Offshore Electricity Transmission - A Joint Ofgem/BERR Regulatory Policy Update

Document type: **Annex**

Ref: URN 08/965 (BERR)

ANNEX 6 - GRID CODE

Figure 4

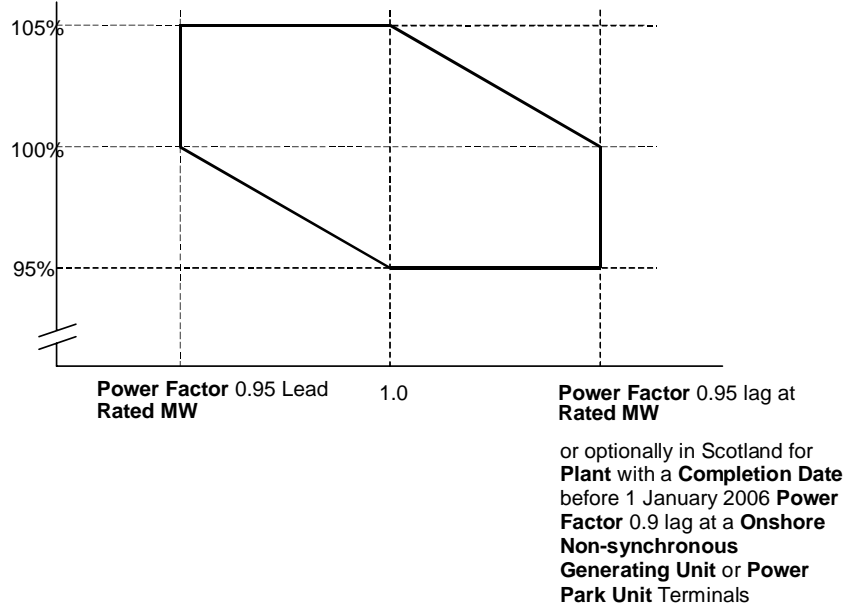
- (a) For any Onshore Generating Unit, Onshore DC Converter and Onshore Power Park Module the Reactive Power output under steady state conditions should be fully available within the voltage range $\pm 5\%$ at 400kV, 275kV and 132kV and lower voltages, except for an Onshore Power Park Module or Onshore Non-Synchronous Generating Unit if Embedded at 33kV and below (or directly connected to the Onshore Transmission System at 33kV and below) where the requirement shown in Figure 4 applies.

~~The Reactive Power output under steady state conditions should be fully available within the voltage range $\pm 5\%$ at 400kV, 275kV and 132kV and lower voltages, except for a Power Park Module or Non-synchronous Generating Unit Embedded at 33kV and below (or directly connected to the GB Transmission System in England and Wales at 33kV and below) where the requirement shown in Figure 4 applies.~~

Figure 5

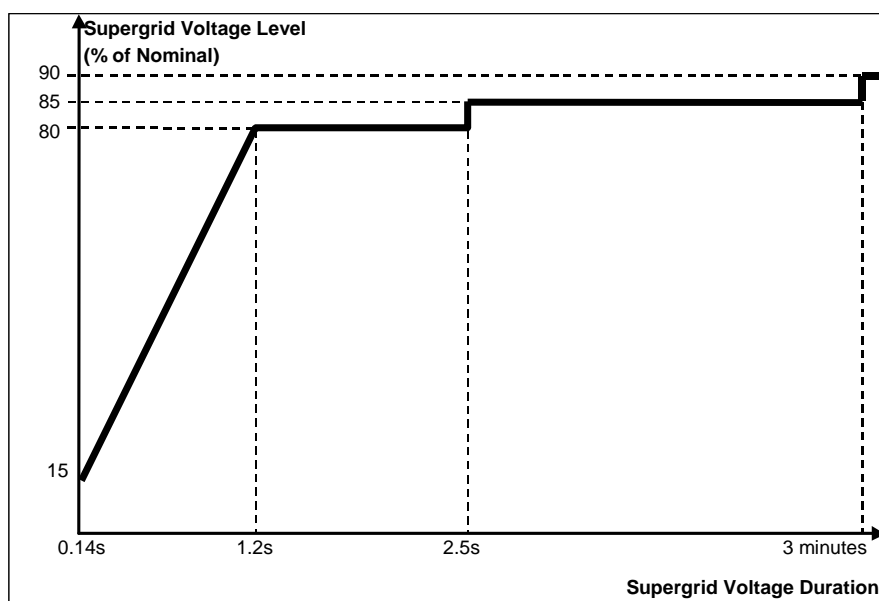
In addition to the requirements of CC.6.3.15.1 (a) each **Generating Unit** or **Power Park Module** and / or any constituent **Power Park Unit**, each with a **Completion Date** on or after the 1 April 2005 shall:

(i) remain transiently stable and connected to the **System** without tripping of any **Generating Unit** or **Power Park Module** and / or any constituent **Power Park Unit**, for balanced **Supergrid Voltage** dips and associated durations on the Onshore Transmission System (which could be at the Interface Point) anywhere on or above the heavy black line shown in Figure 5. Appendix 4A and Figures CC.A.4A.3 (a), (b) and (c) provide an explanation and illustrations of Figure 5; and,

- (ii) provide **Active Power** output, during **Supergrid Voltage** dips on the Onshore Transmission System as described in Figure 5, at least in proportion to the retained balanced voltage at the Onshore Grid Entry Point or Interface Point (or the retained balanced voltage at the **User System Entry Point** located Onshore if **Embedded**) except in the case of a **Non-Synchronous Generating Unit** or **Power Park Module** where there has been a reduction in the **Intermittent Power Source** in the time range in Figure 5 that restricts the **Active Power** output below this level and shall generate maximum reactive current without exceeding the transient rating limits of the **Generating Unit** or **Power Park Module** and any constituent **Power Park Unit**; and,

- (iii) restore **Active Power** output, following **Supergrid Voltage** dips on the Onshore Transmission System as described in Figure 5, within 1 second of restoration of the voltage at the:-

to the minimum levels specified in CC.6.1.4 ~~(or within 1 second of restoration of the voltage at the User System Entry Point to 90% of nominal or greater if Embedded)~~, to at least 90% of the level available immediately before the occurrence of the dip except in the case of a **Non-Synchronous Generating Unit** or **Power Park Module** where there has been a reduction in the **Intermittent Power Source** in the time range in Figure 5 that restricts the **Active Power** output below this level. Once the **Active Power** output has been restored to the required level, **Active Power** oscillations shall be acceptable provided that:

Figure 6

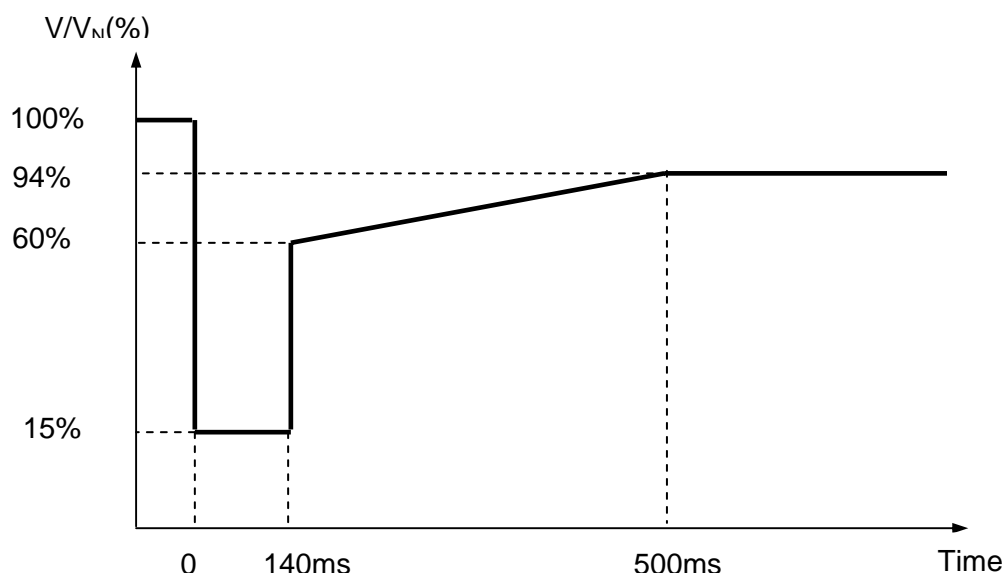
(i) Each Offshore Generating Unit, Offshore DC Converter, or Offshore Power Park Module and any constituent Power Park Unit thereof shall remain transiently stable and connected to the System without tripping of any Offshore Generating Unit, or Offshore DC Converter or Offshore Power Park Module and / or any constituent Power Park Unit, for any balanced or unbalanced voltage dips on the LV Side of the Offshore Platform whose profile is anywhere on or above the heavy black line shown in Figure 6. (or for an equivalent load rejection if connected to an Offshore Transmission System which includes a DC Converter). For the avoidance of doubt, the profile beyond 140ms in Figure 6 shows the minimum recovery in voltage that will be seen by the generator following clearance of the fault at 140ms. Appendix 4B and Figures CC.A.4B.2 (a) and (b) provide further illustration of the voltage recovery profile that may be seen.

V/V_N is the ratio of the actual voltage on one or more phases at the LV Side of the Offshore Platform to the nominal voltage of the LV Side of the Offshore Platform. The nominal voltage at the LV side of the Offshore Platform would typically be 33 kV.

~~(i)~~(ii) Each Offshore Generating Unit, or Offshore Power Park Module and any constituent Power Park Unit thereof shall provide Active Power output, during voltage dips (or load rejections if connected to an Offshore Transmission System which includes a DC Converter) on the LV Side of the Offshore Platform as described in Figure 6, at least in proportion to the retained voltage at the LV Side of the Offshore Platform except in the case of a Offshore Non-Synchronous Generating Unit or Offshore Power Park Module where there has been a reduction in the Intermittent

Figure 7

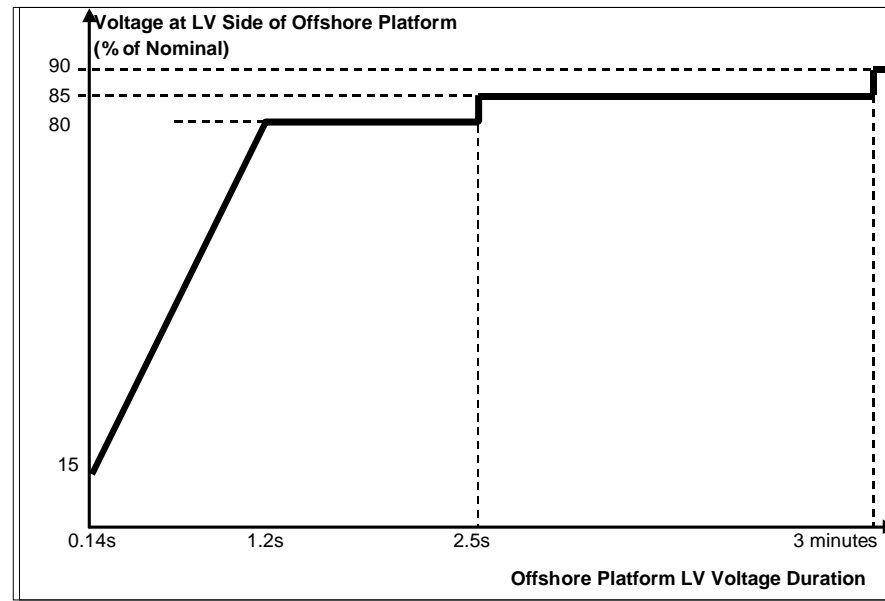
In addition to the requirements of CC.6.3.15.2. (a) each Offshore Generating Unit or Offshore Power Park Module and / or any constituent Power Park Unit, shall:

(i) remain transiently stable and connected to the System without tripping of any Offshore Generating Unit or Offshore Power Park Module and / or any constituent Power Park Unit, for any balanced voltage dips on the LV side of the Offshore Platform and associated durations anywhere on or above the heavy black line shown in Figure 7, (or an equivalent load rejection if connected to an Offshore Transmission System which includes a DC Converter).. Appendix 4B and Figures CC.A.4B.3. (a), (b) and (c) provide an explanation and illustrations of Figure 7;

(ii) provide **Active Power** output, during voltage dips (or equivalent load rejections, if connected to an **Offshore Transmission System** which includes a **DC Converter**) on the **LV Side of the Offshore Platform** as described in Figure 7, at least in proportion to the retained balanced or unbalanced voltage at the **LV Side of the Offshore Platform** except in the case of a **Offshore Non-Synchronous Generating Unit** or **Offshore Power Park Module** where there has been a reduction in the **Intermittent Power Source** in the time range in Figure 7 that restricts the **Active Power** output below this level and shall generate maximum reactive current without exceeding the transient rating limits of the **Offshore Generating Unit** or **Offshore Power Park Module** and any constituent **Power Park Unit**; and,

(iii) within 1 second of the restoration of the voltage at the **LV Side of the Offshore Platform** (to the minimum levels specified in CC.6.1.4) restore **Active Power** to at least 90% of the **Offshore Generating Unit's** or **Offshore Power Park Module's** immediate pre-disturbed value, unless there has been a reduction in the **Intermittent Power Source** in the time range in Figure 7 that restricts the **Active Power** output below this level. **Once the Active Power output has been restored to the required level, Active Power oscillations shall be acceptable provided that:**
